**PROJECT**  
 ALTERATIONS TO  
 APARTMENTS 11 & 14  
 THE GRAND  
 PLYMOUTH  
 FOR Mr & Mrs O'SULLIVAN

**DRAWING TITLE**  
 INDICATIVE  
 SECTION

DRAWING NO:	REV
21015 - Sk.09	A

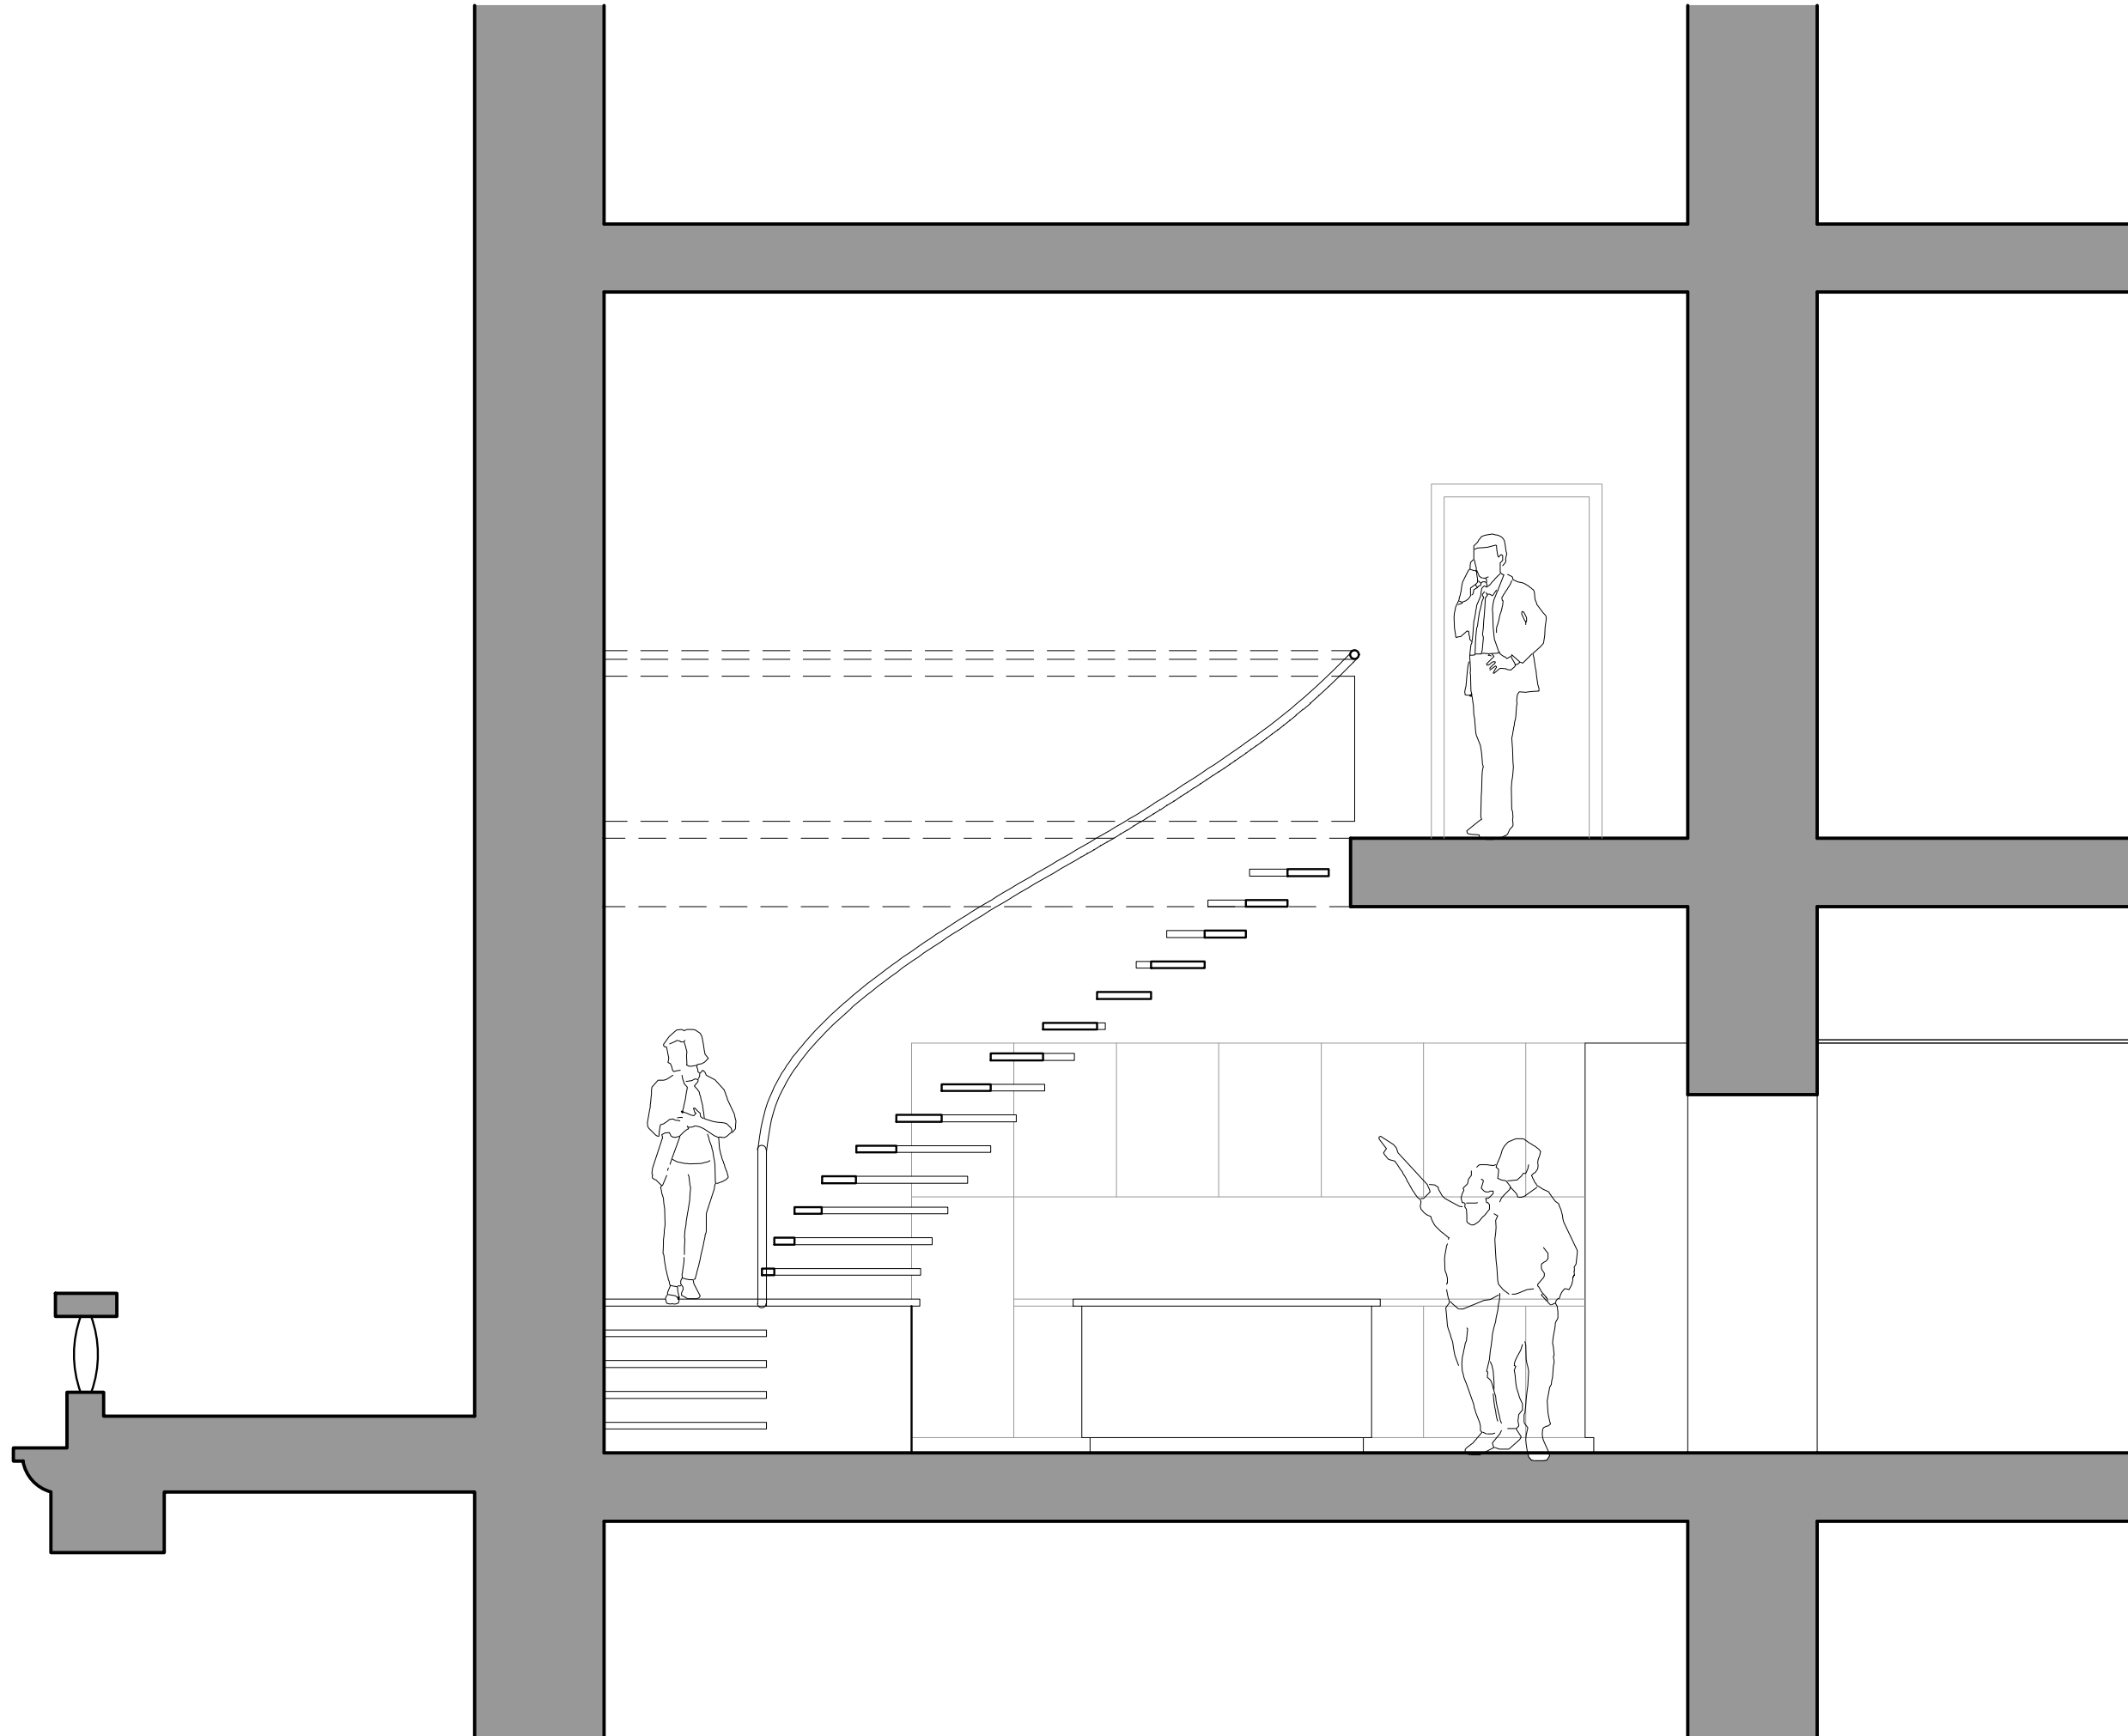
A 19.08.21 Platform raised by 180mm, riser added to bottom flight, riser omitted from top flight. Door removed from new glazed partition.
